Comments on Draft 1 of the ENERGY STAR for Windows, Doors, and Skylights Version 6.0 Specification

**Respectfully Submitted by the Association of Millwork Distributors (AMD)
September 28, 2012**

Figure A-2A
Sample Temporary Door Matrix Label (2011)

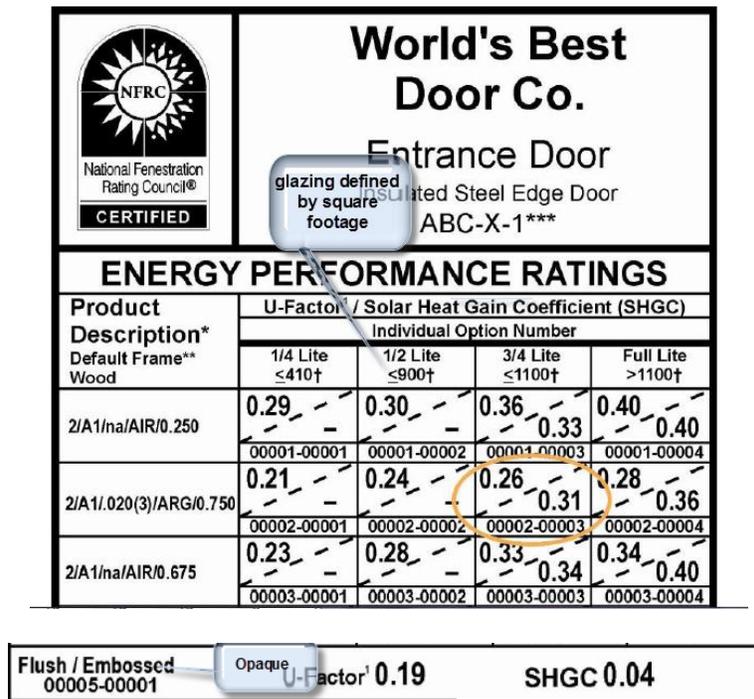
Comment: Percentages are not used in the industry to define area of glazing. The NFRC 100 does not reference percentages either. And even if one were to calculate percentages based on the NFRC standard sizes and square footage of glazing area, none of the calculations come to 29.8% glazing. Perhaps this is an average percentage that is being referenced? This will add a great deal of confusion to the industry and consumers alike because another measurement criterion is being used. The NFRC Door Label references glazing area by square footage in the categories of ¼ lite, ½ lite, ¾ lite and full lite, which is based on the NFRC 100.

Recommendation: Replace the percentage reference with reference to glazing area by square footage as defined in Table 5-1 of the NFRC 100 and the NFRC Door Label. Energy Star should recognize the glazing categories as defined by NFRC:
